UNITED STATES PATENT AND TRADEMARK OFFICE

10/579,528

Office Action Summary	Application No. 10/579,528	Applicant(s) ALBRECHT ET AL.	
	Examiner PHILLIP NGUYEN	Art Unit 2828

DETAILED ACTION

FIG. 2

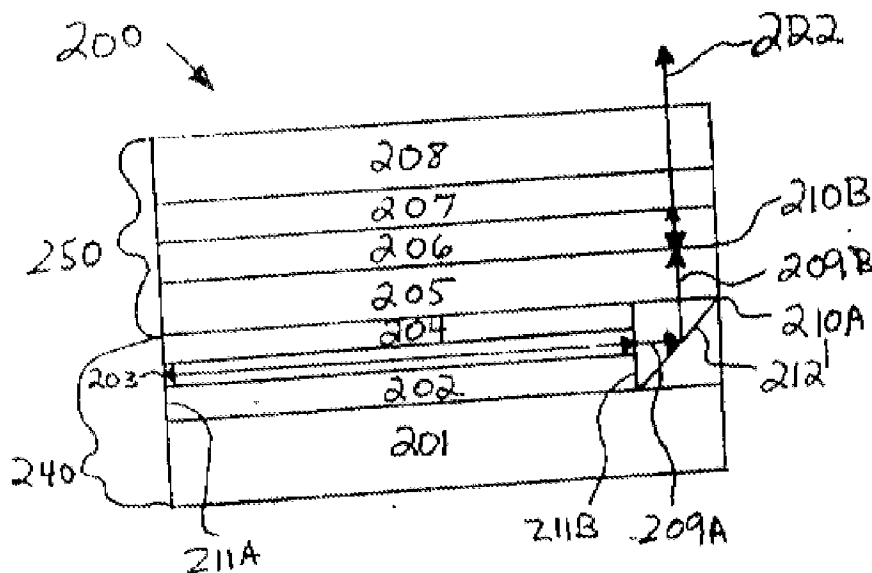
With respect to claim 1, Albrecht discloses in Fig. 2 (as shown above) a semiconductor laser device 200 comprising:

an optically pumped surface-emitting vertical emitter region 250 which has an active radiation-emitting vertical emitter layer 206;

at least one monolithically integrated pump radiation source 240 for optically pumping the vertical emitter 250, which has an active radiation-emitting pump layer 203, wherein the pump layer follows the vertical emitter layer in the vertical direction and a main direction of pump radiation from the monolithically integrated pump radiation source is lateral;

a conductive layer 204 provided between the vertical emitter layer 206 and the pump layer 203; and a contact 201/204 applied on the side of the semiconductor laser device which is closer to the pump layer than to the conductive layer;

whereby an electrical field can be applied between the conductive layer and the contact for generating pump radiation by charge carrier injection.

It's noted that the in paragraph 0017, Jiang further discloses "the substrate 201 or cladding layer 202 may act as the contact layer for making one of the electrical contacts for the electrically pumped in-plane semiconductor laser." The contact 201/204 is located on the bottom/lower side of the pump layer. It's further noted that in claim 13, applicant also use the term "on the side opposite the substrate" to explain the position of the radiation generated by the vertical emitter layer.

With respect to claim 2, Fig. 2 illustrates the semiconductor laser device 200 being partially ablated in the region of beam steering element so that the beam steering element can be placed in that area replacing the ablated portion.

With respect to claim 4, since the claim fail to define "a further contact" to be an electrical contact which is applied to the exposed areas of the conductive layer, it is Examiner's position to interpret that the facet 211B to be that "further contact."

With respect to claim 8, DBR 205 is considered as a vertical waveguide structure which is provided between the vertical emitter layer 206 and the conductive layer 204.

With respect to claims 11-12, DBR 205 is again considered as an internal cavity reflective surface.

With respect to claim 13, Fig. 1 shows the internal cavity reflective structure 205 being arranged between the vertical emitter layer 206 and a substrate 201 and the radiation generated by the vertical emitter layer is launched on the side of opposite the substrate.

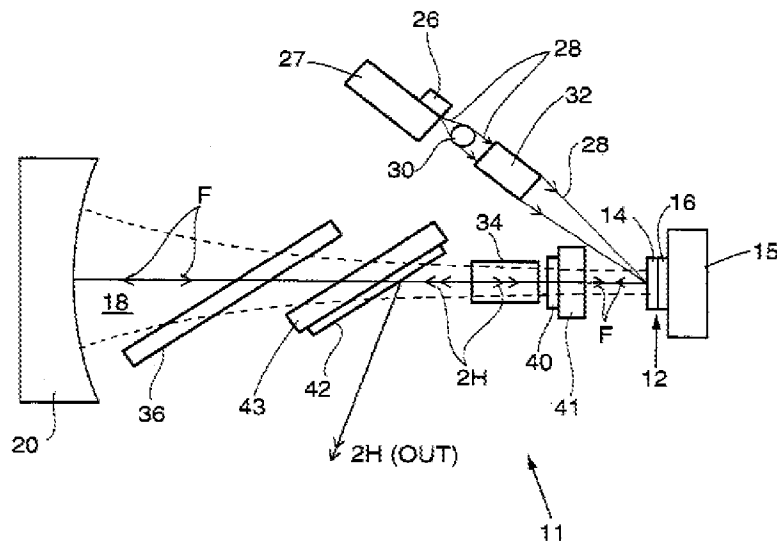
Claim 3 is rejected under 35 U.S.C. 103(a) as being unpatentable over Jiang et al. (US 2003007538) in view of Chua et al. (US 20030067009). Jiang discloses the claimed invention except for the semiconductor laser device being ablated in the form of parallel trenches. Chua discloses in Fig. 1b a VCSEL that has an ablated region in the form of parallel trenches 110. It would have been obvious to one skill in the art at the time the invention was made to provide

parallel trenches as taught by Chua in order to oxidize the layer inside of the VCSEL to change its refractive index.
